Take the two parallel hydraulic lines between the irreversible valve and hydraulic pump for the collective pitch control on your Huey (UH-1B).

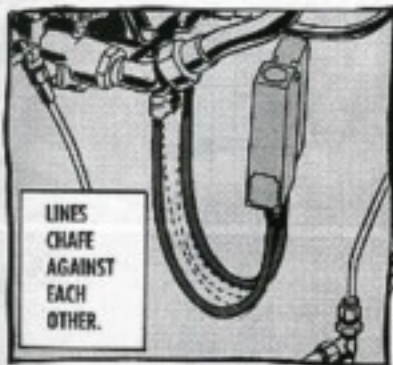
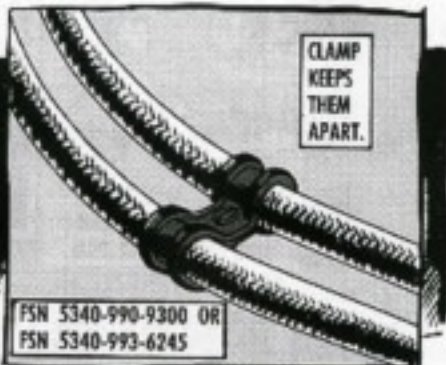
Vibration can cause one line to chafe against the other, which is the reason the contractor is now putting a clamp between them on Baker models starting with Serial Number 64-13902. After all, a ruptured line could ruin a pilot's whole day.

LINES
CHAFE
AGAINST
EACH
OTHER.

CLAMP
KEEPS
THEM
APART.

FSN 5340-990-9300 OR
FSN 5340-993-6245
